10 **SEDGWICK CO COURTHOUSE – DA 2ND & 3RD FLOOR
REMODEL
Sedgwick County**

20 Prepared by:
Schaefer Johnson Cox Frey Architecture, Inc.

PRE-BID QUESTIONS:

1 LEVEL 2 - DA RENOVATION PLAN
 1/8" = 1'-0"

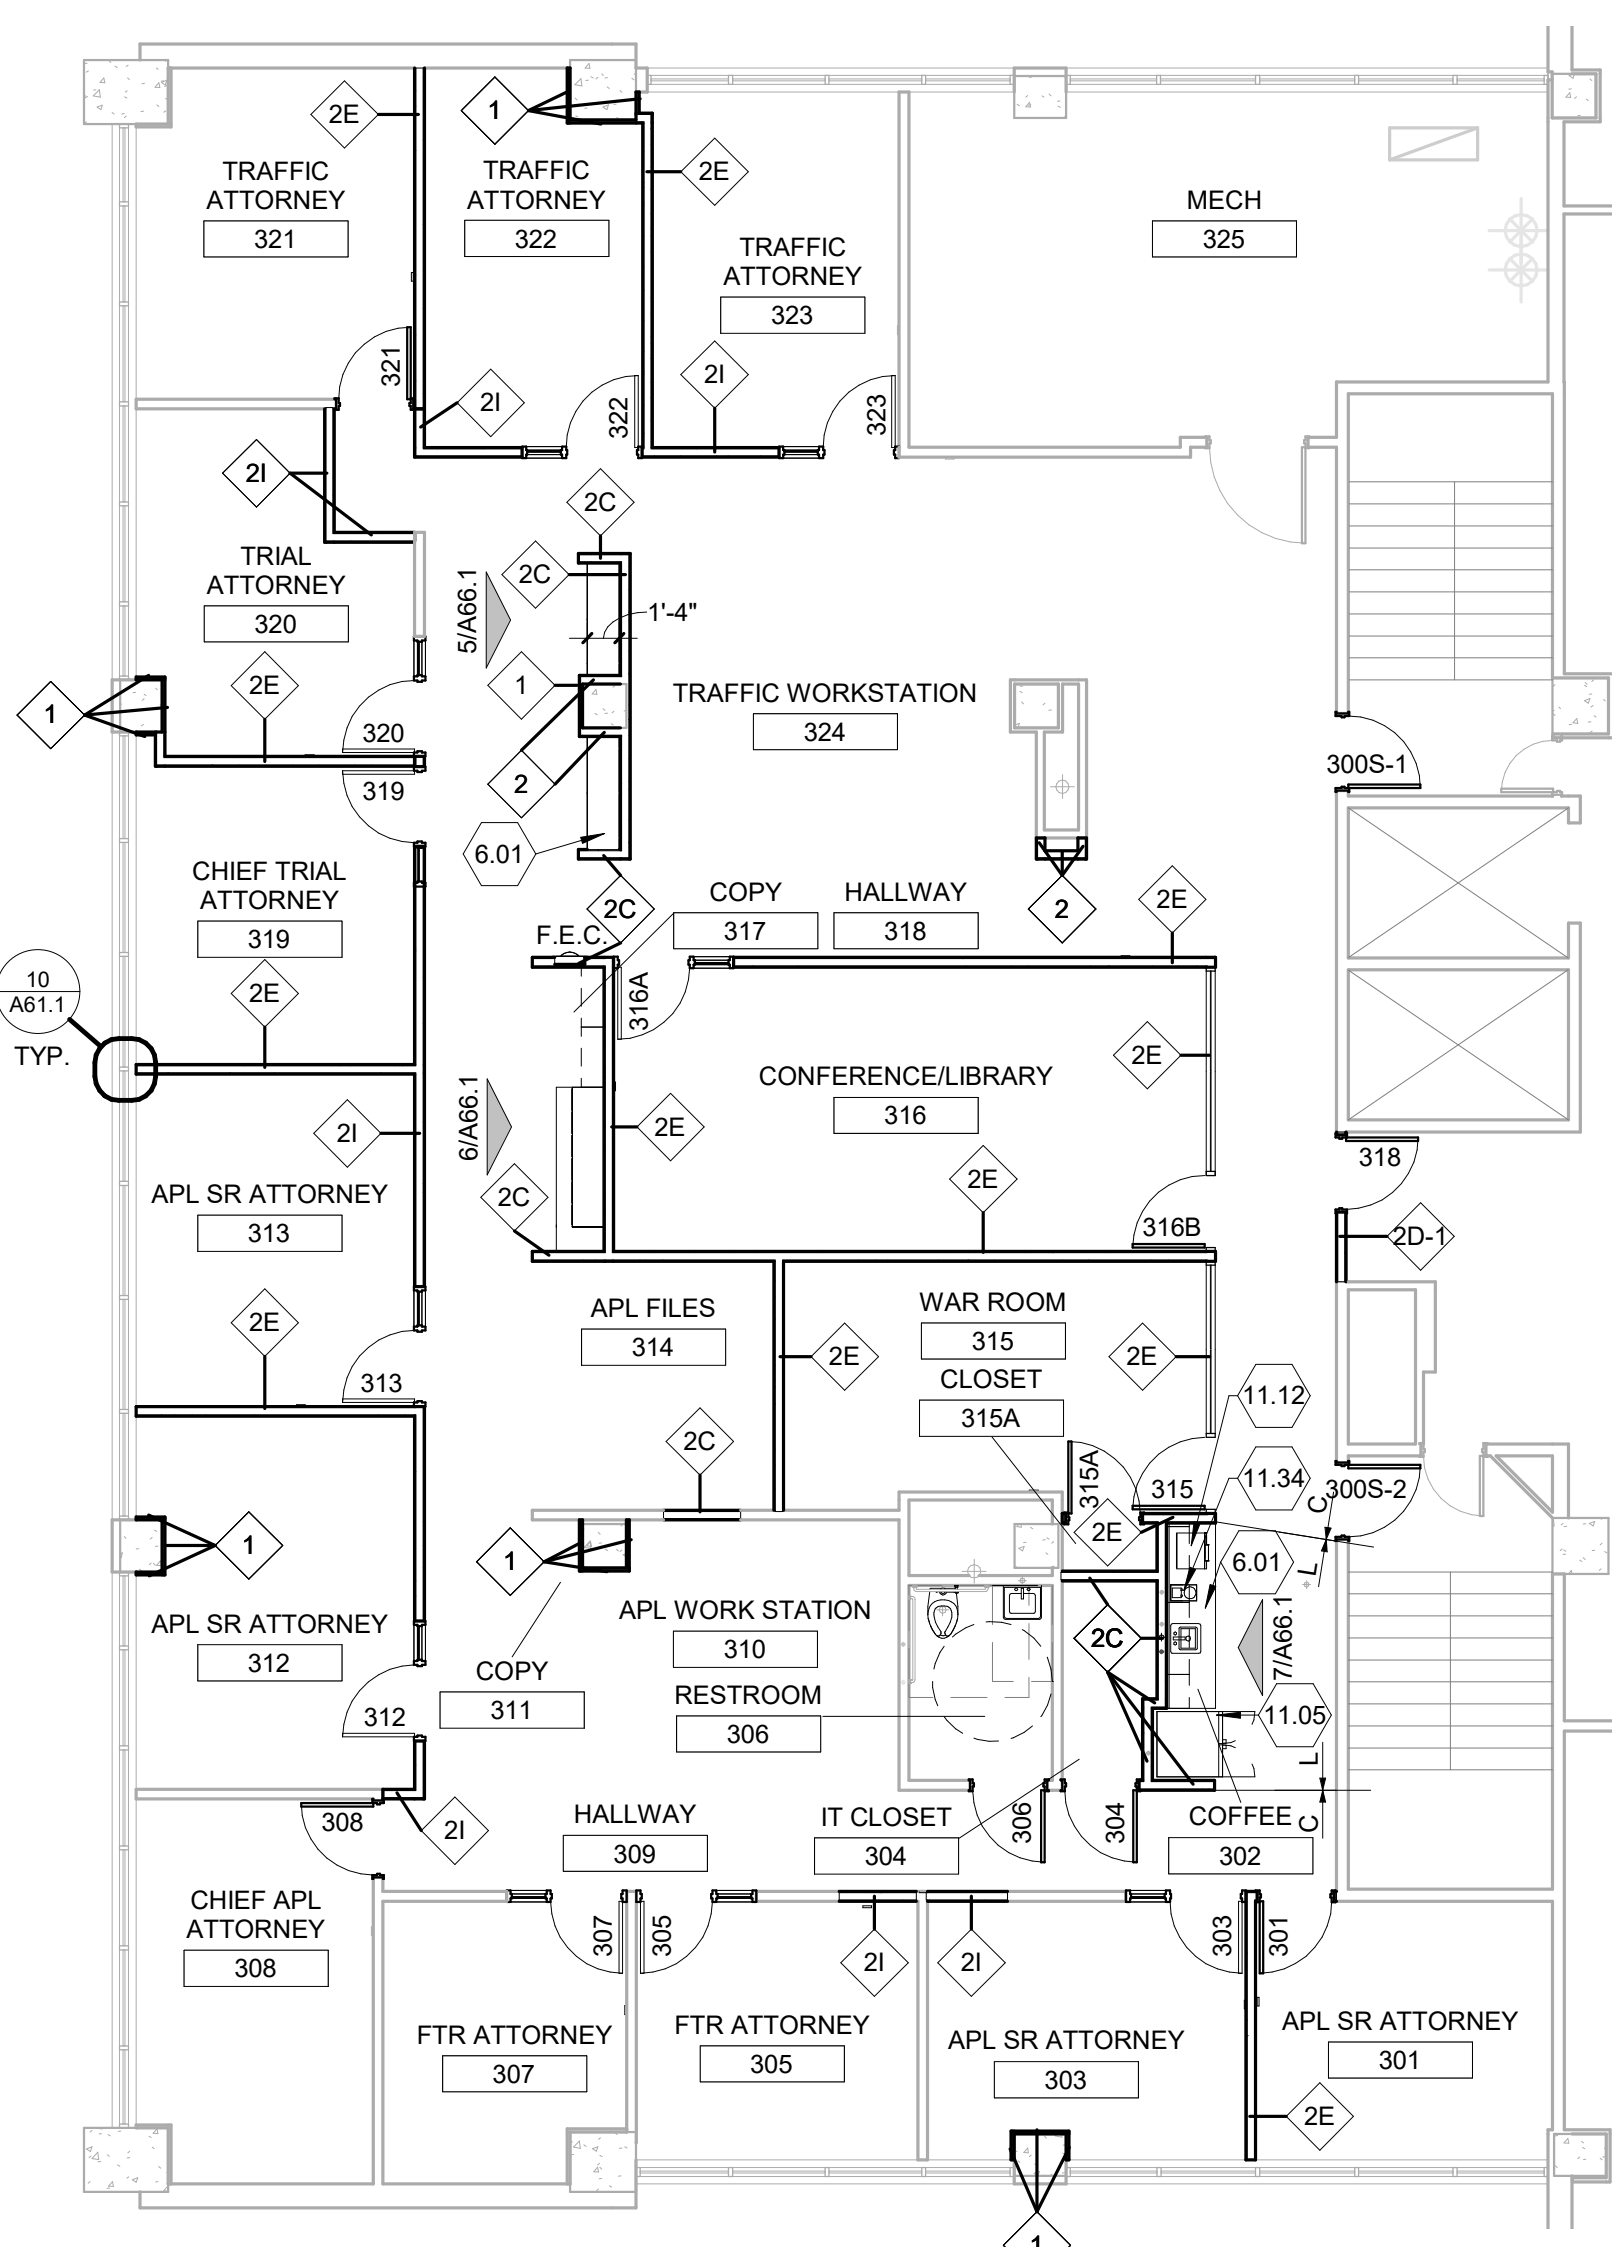
DRAWING SHEET A22.1, Level 2 DA Renovation Plan:
Add corridor 234 with T2 floor finish per attached.

4 RESTROOM ELEVATION
 3/8" = 1'-0"

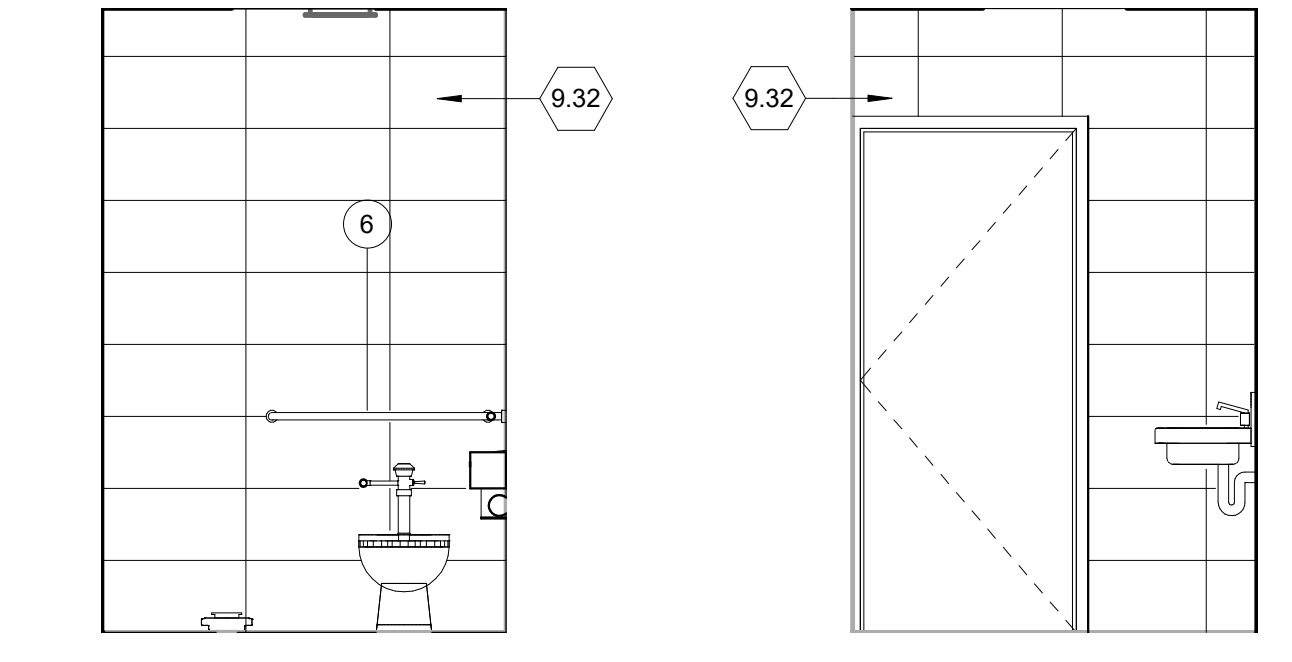
DRAWING SHEET A22.1, RESTROOM ACCESSORIES SCHEDULE:
Wall Hung Mirror, Revise Height/Length of Mirror from 36" to 40".
